**American Champion Aircraft Corp.  
Rochester, WI 53167**

Service Letter: 422 Revision "A" (Page 1 of 4)

Title: Aluminum Gear Retrofit

Models: Bellanca/American Champion 7ECA, 7GCAA, 7GCBC, 7KCAB, 8KCAB, 8GCBC

**Figure 1, 1-9998-1 Fairing Tube Installation**

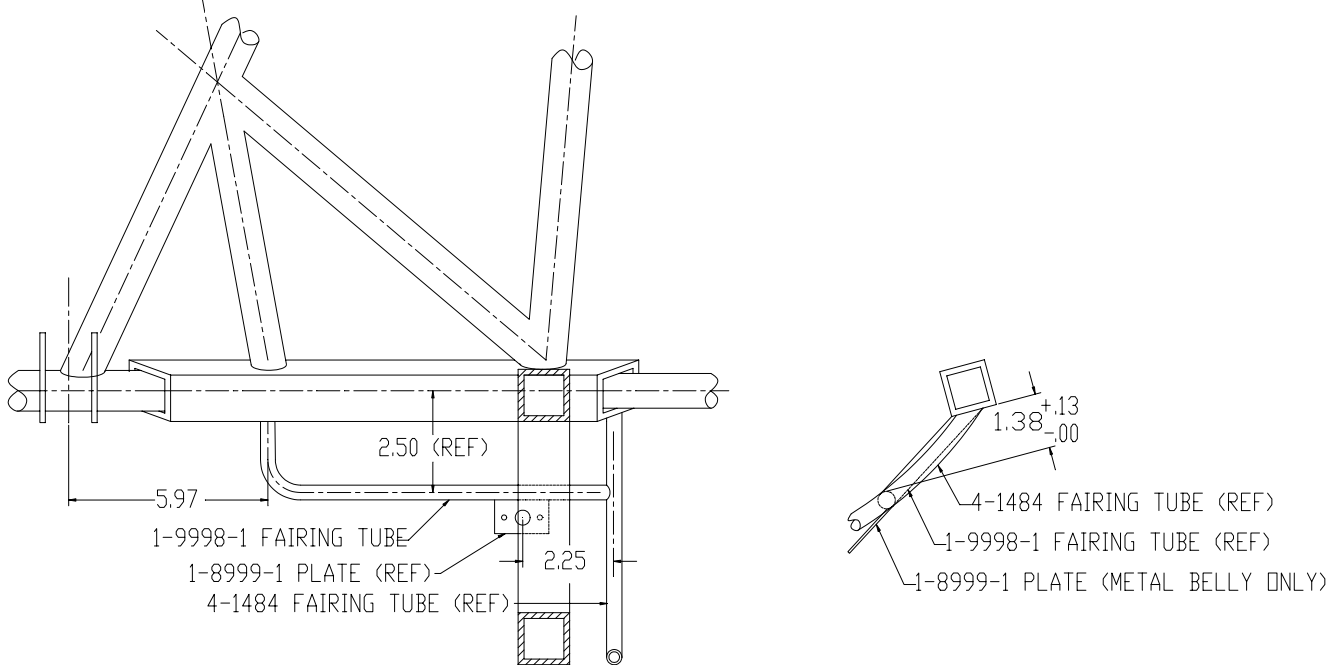
1. Refer to Service Manual for jacking of aircraft and procedure for removal of the old main landing gear leg assembly.
2. Remove fabric to expose 1-9998 fairing tube.
3. Remove 1-9998 tube, cut and grind flush to fuselage frame and 4-1484 fairing tube.
4. Grind 1-9998-1 tube to mate with fuselage frame.
5. Install 1-9998-1 tube per figure 1, weld per Champion Specification CW-1 or other industry accepted process for tubular steel welding.

6. If metal belly installed, install 1-8999-1 plate per figure 1, weld per CW-1 or other industry accepted process for tubular steel welding.
7. Treat all bare surfaces with zinc-chromate primer or equivalent.
8. Patch fabric and repaint in accordance with applicable ACAC service manual.

**Figure 2, 3-1498 Skin Cutout**

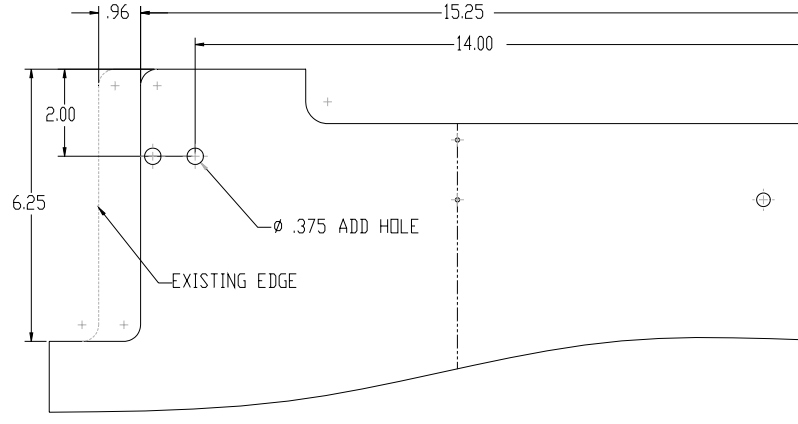
9. If metal belly installed, modify 3-1498 skin per figure 2.

**Figure 3, 2-2111-9 Brake Line Installation**

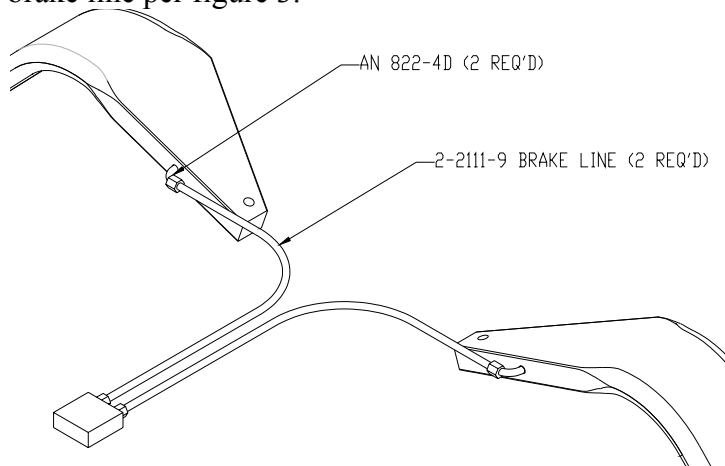
- 10. Install aluminum gear legs per ACAC drawing 7-1559 (no rev. or later) for all models except 8GCBC, for 8GCBC install per ACAC drawing 7-1579 (no rev. or later).
- 11. Remove 2-2111-8 (7-Series and 8KCAB) or 2-2133-2 (8GCBC) brake line and hardware and install 9563K84 snap plug in boot cowl.
- 12. Install 2-2111-9 brake line per figure 3.

**Figure 4, Wheel Pant Cutout**

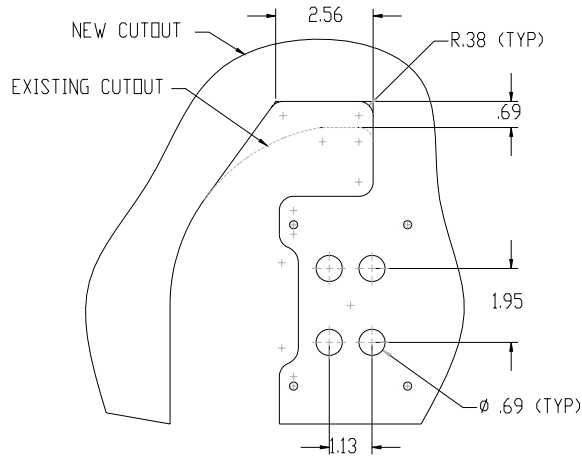
13. Modify wheel pant (Part Number 7-1541 L/R) per figure 4.
